RESIDENTIAL ENGINEERING SERVICES, LLC.
SHOP DRAWINGS/SUBMITTAL REVIEW

JOB No.	2745269
DESCRIPTION	Summit Homes - Woodside Ridge #25
JOB ADDRESS	2113 NW Ashurst Drive
CITY	Lee's Summit, MO
DESIGNER	Scott Clevenger
DATE	4/9/2021

ROOF
TRUSS LAYOUT

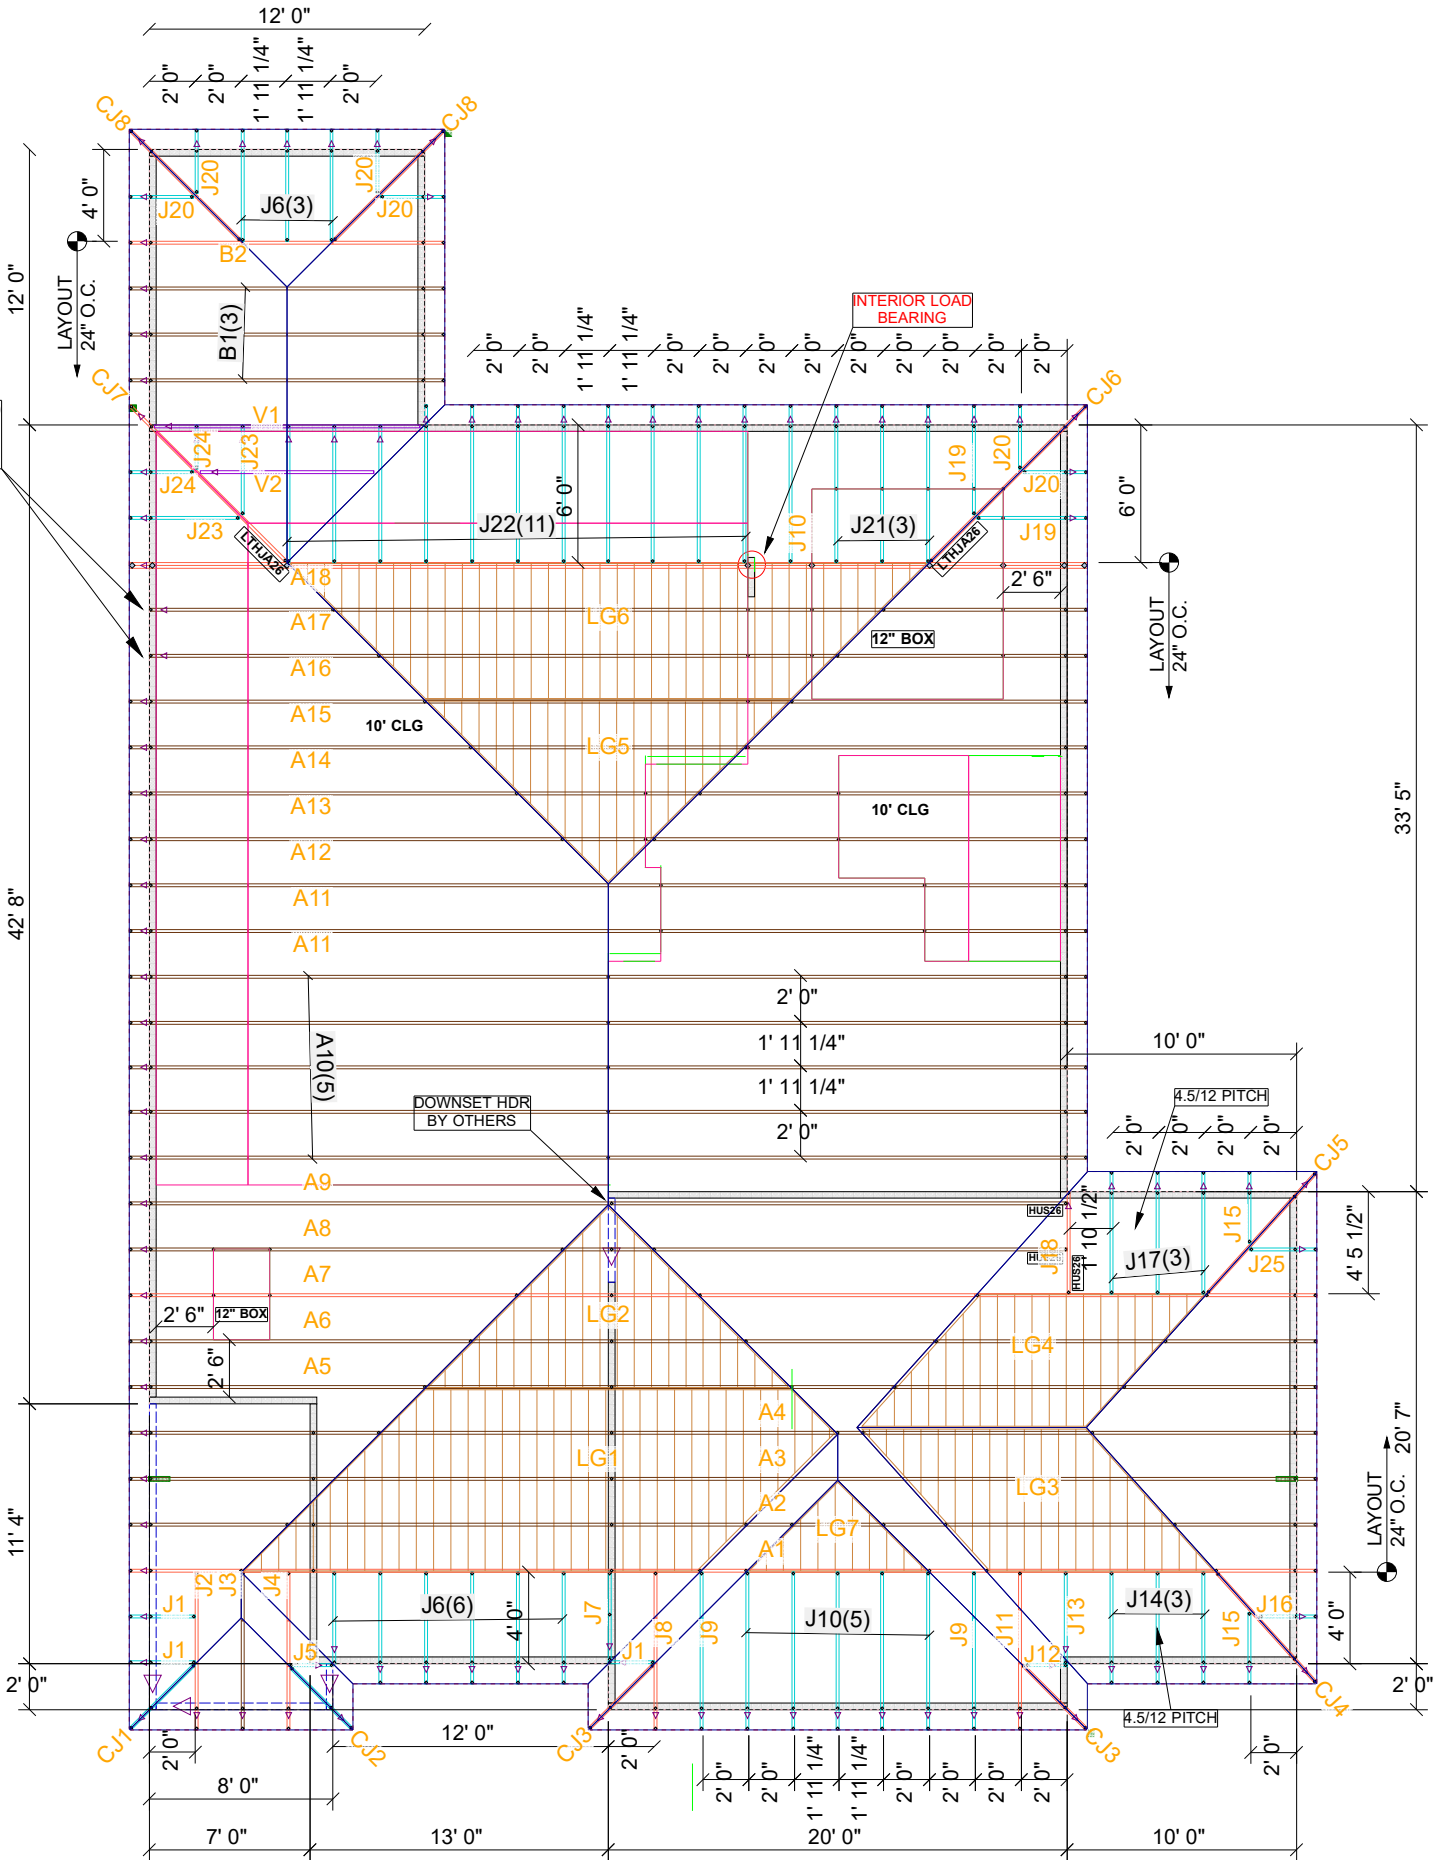
ATTACH PROVIDED
2X8 SCAB PER
ENG DWG NOTES
